CONWAY
HISTORIC DISTRICT COMMISSION
AUGUST

6:00pm • August 22, 2016 • City Hall

AGENDA

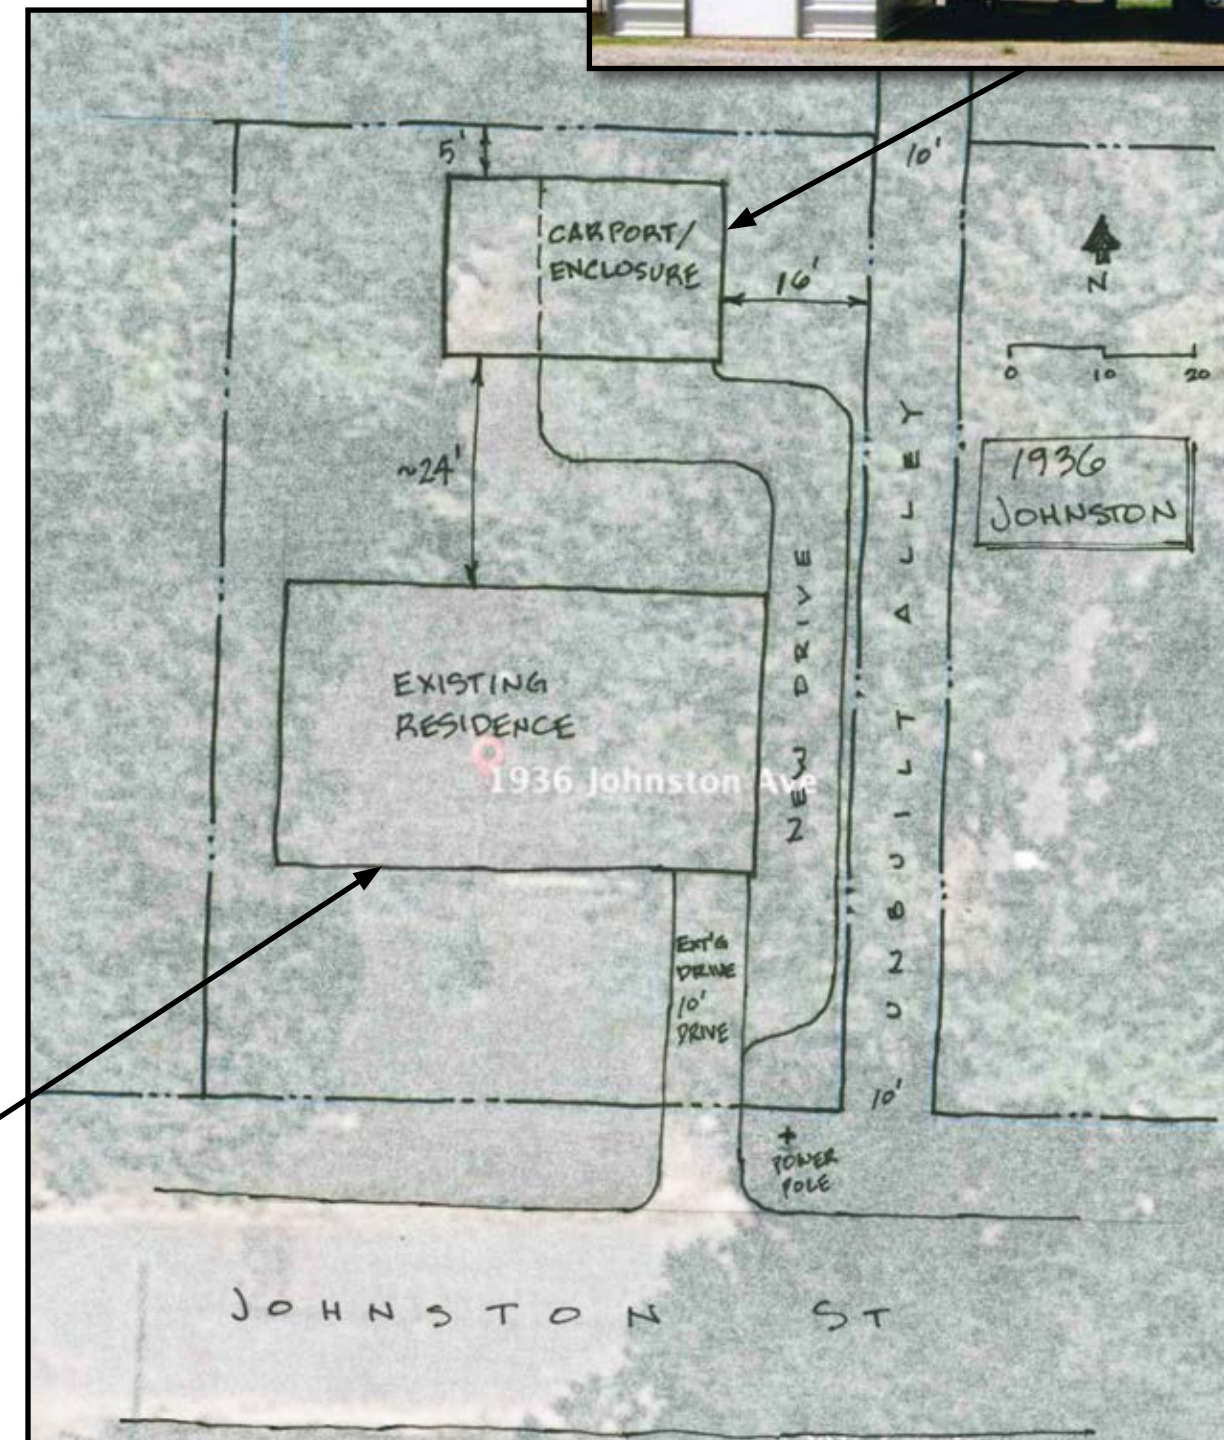
Style. The style should compliment area structures. The residence is a brick ranch style house with an open carport. The proposed rear yard carport is a metal structure that does not particularly blend with the residence's style, however, it is mostly hidden from public view in the rear yard.

Doors and windows. The rhythm, patterns, and ratio of voids to solids of new buildings should relate to and be compatible with adjacent façades; typically a higher proportion of voids to wall area. The carport is an open structure with the exception of the small enclosed area. The enclosed area will have a door facing the house.

1. The carport and additional driveway shall be constructed as shown in submitted plans.

Vertical window orientation preferred

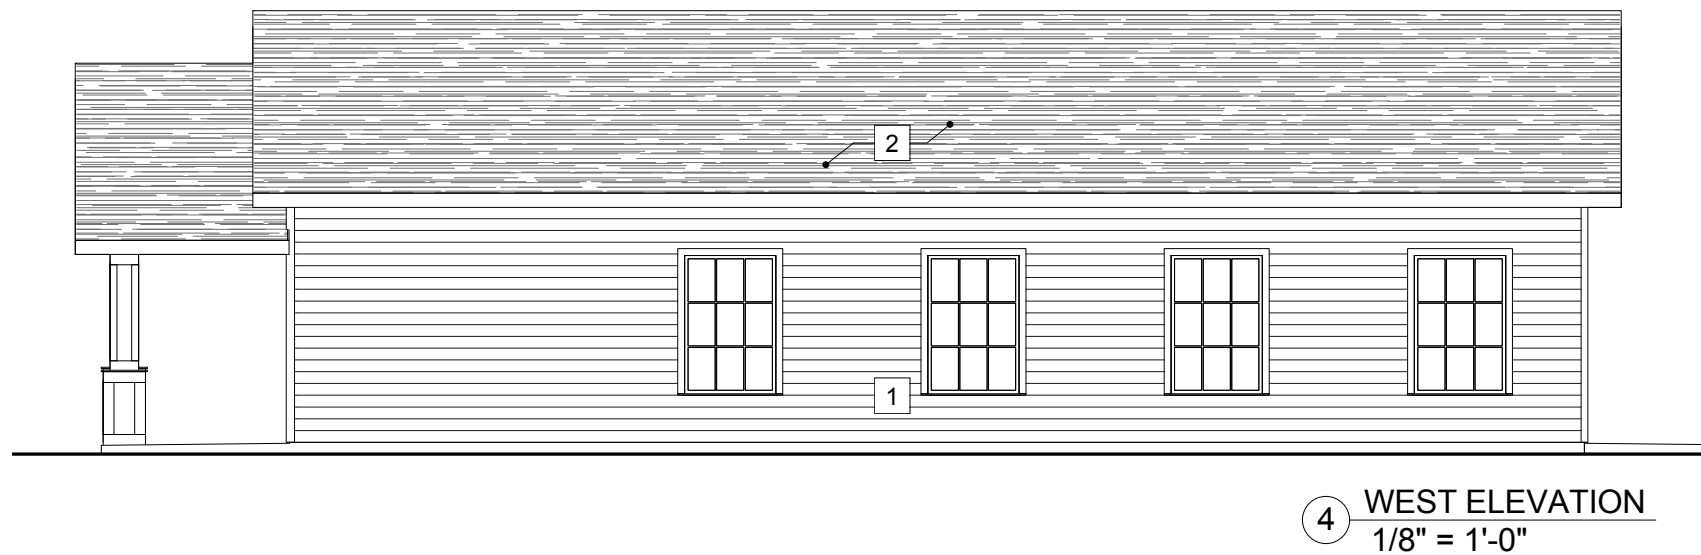
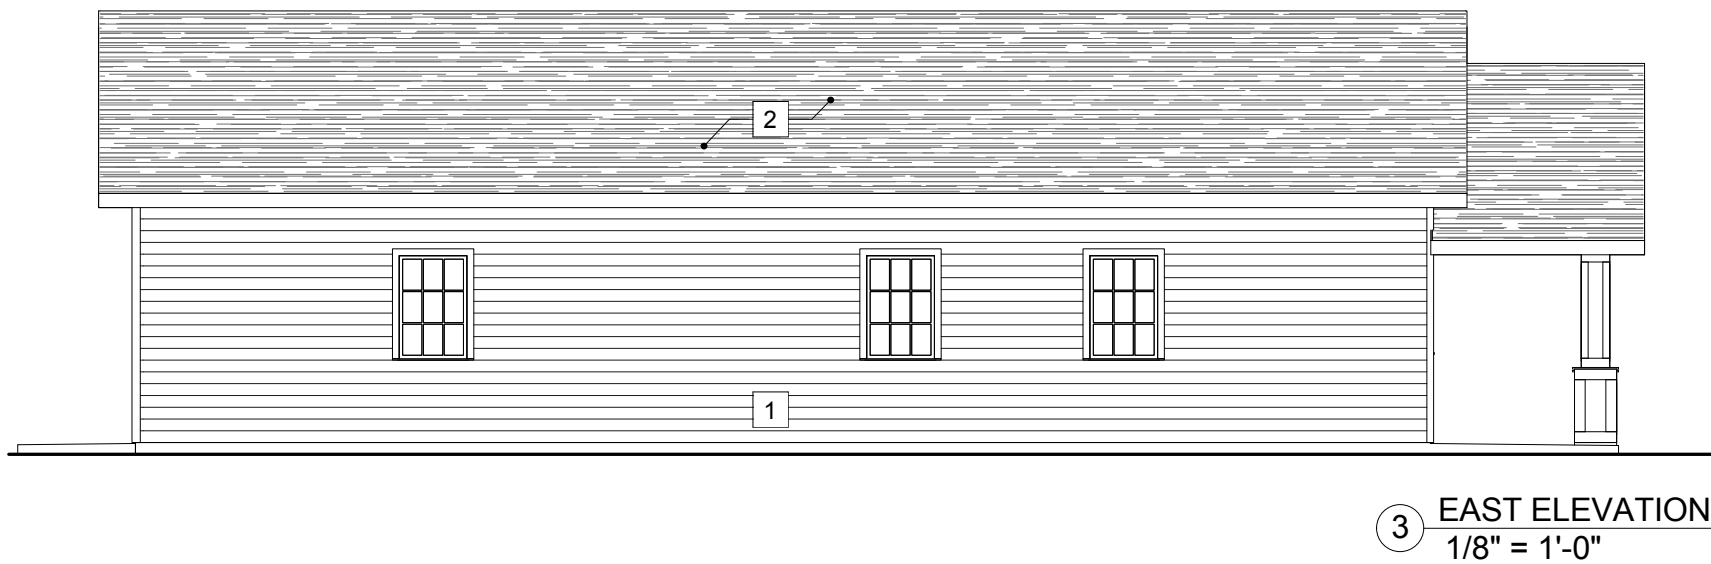
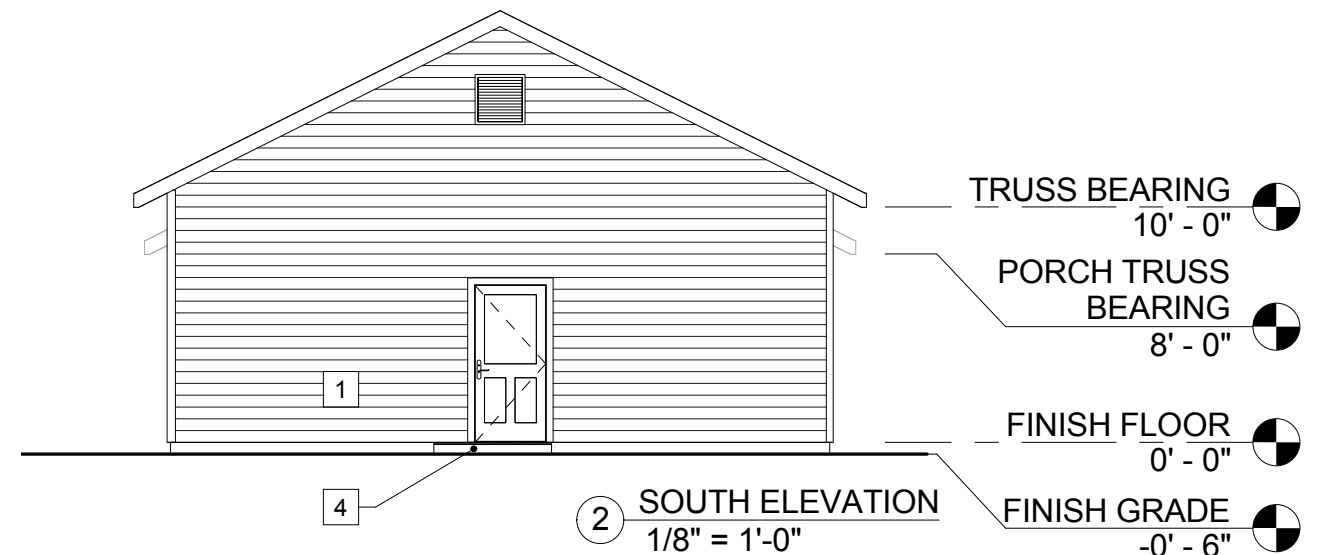
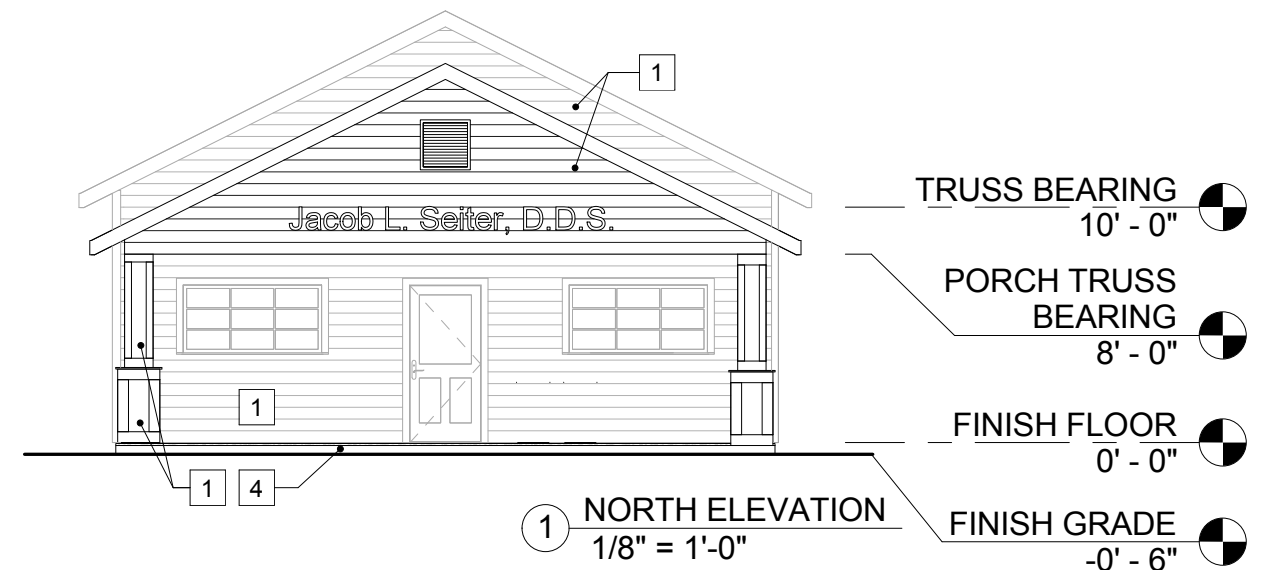
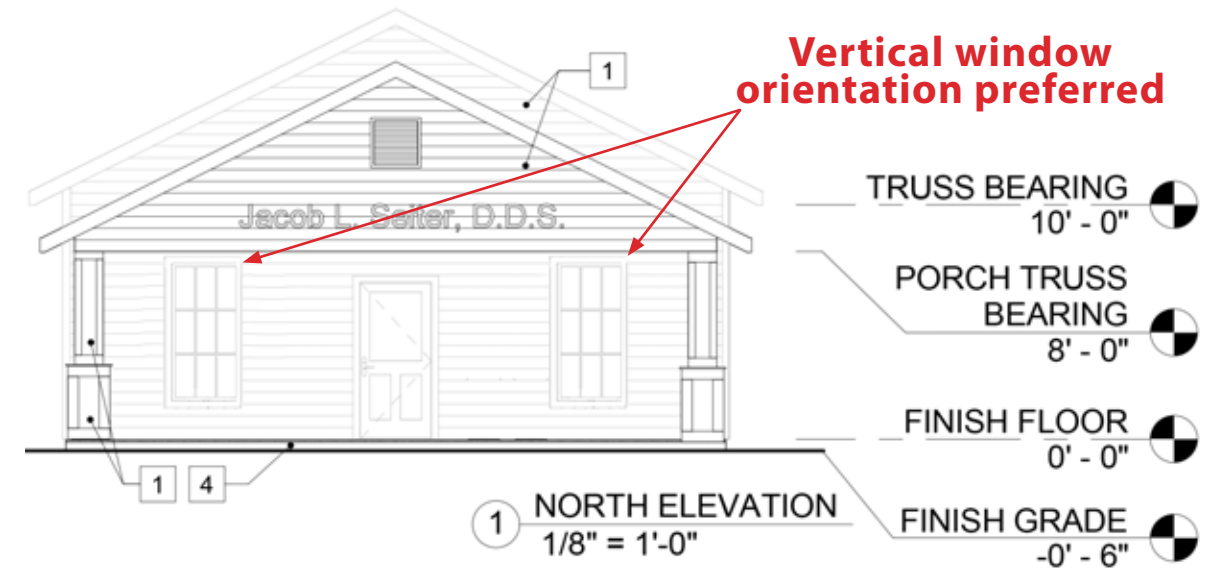
Façade, wall area, rhythm. Façades shall be compatible with surrounding historic structures in proportion of wall to opening area. The office has an appropriate number windows matching the 50% solid to void guideline on the west elevation. The east elevation has a reduced number of windows, however, there is a sterilization and mechanical room on this side of the office. The rear has no windows, but is unseen from the public right of way. The front windows are horizontal in nature. This is likely to allow waiting room seating. Vertical windows are more traditional and would still allow seating. The shape of the windows could be rotated and possibly doubled. (see alternate window orientation on facing page)

1. The office and parking area shall be constructed as shown in submitted plans.
2. A low wall and/or shrubs shall be placed on the south side of the handicap space to provide parking lot screening.
3. Siding shall be Hardi-board or similar cement siding.
4. The front façade windows shall be rotated to a vertical orientation and doubled?
5. HVAC units shall be visually located away from streets or screened by landscaping.
6. Landscaping, dumpster location/pen (if necessary), and cross access shall be placed and constructed per development review standards.
7. Driveway width reduction?

Site Plan

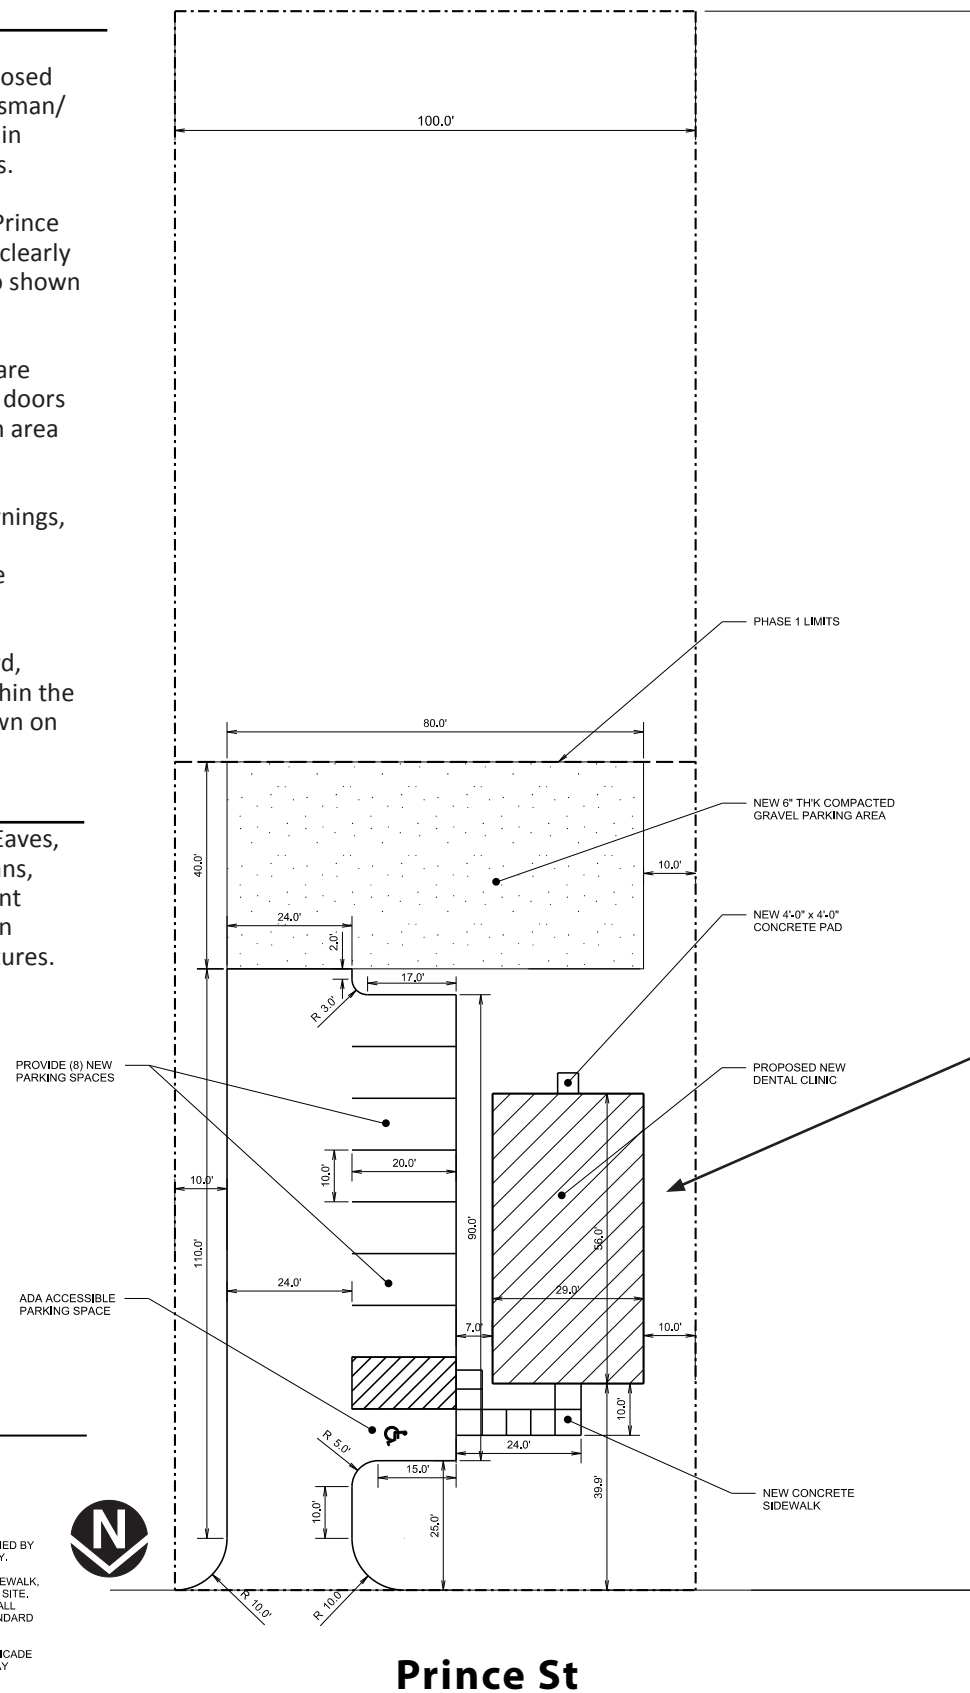
Driveway/Parking. A 24 foot wide curb cut from Prince Street is proposed. This driveway leads to a side parking area with 8 parking spaces. Old Conway guidelines encourage a rear parking arrangement over a side parking area. However, a side parking area allows more developable land on the south side of the lot. The curb cut width could be decreased to a more residential style width of 12-18 feet.

Perspective (view from Prince St looking SW)

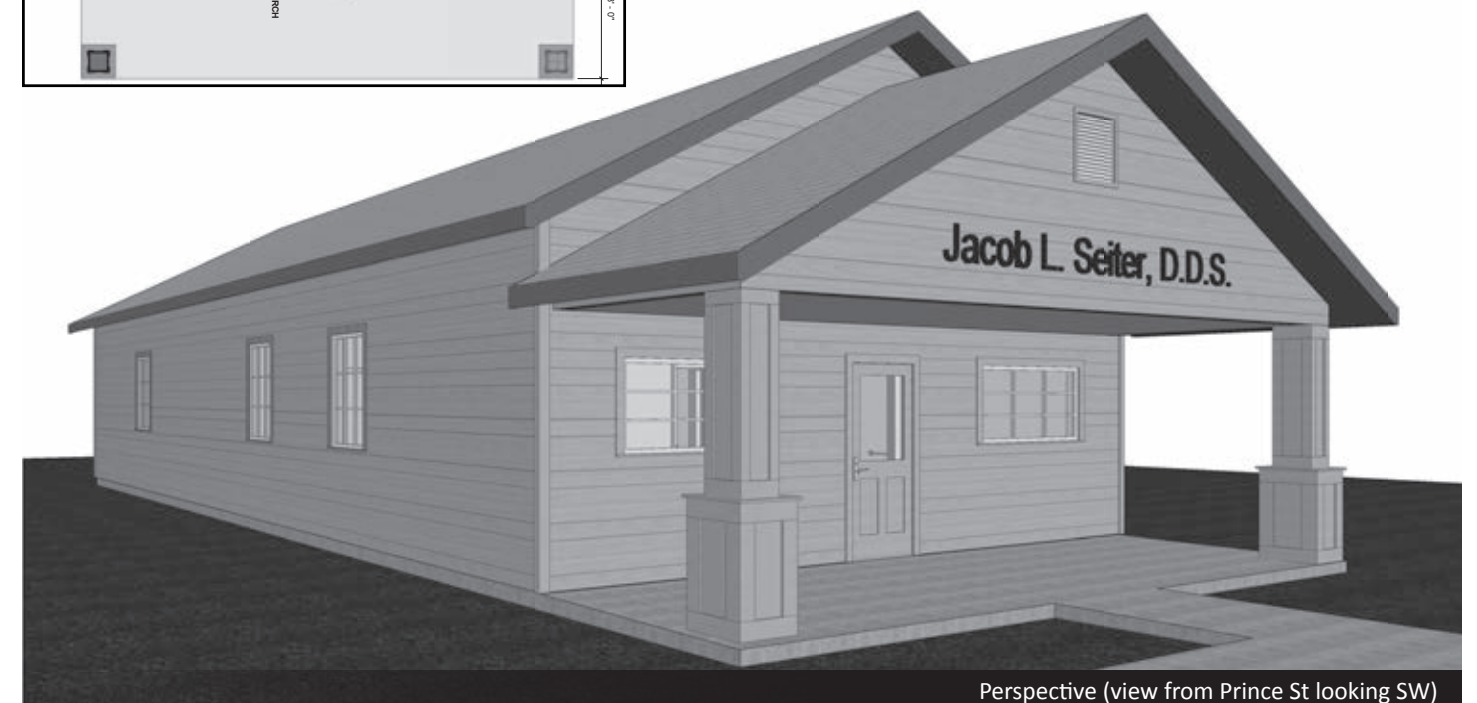
Mechanical Screening. HVAC units should be visually located away from streets or screened by landscaping. Exterior HVAC ductwork should not be visible from the street. HVAC equipment appears to be located appropriately at the rear of the office. (south elevation)
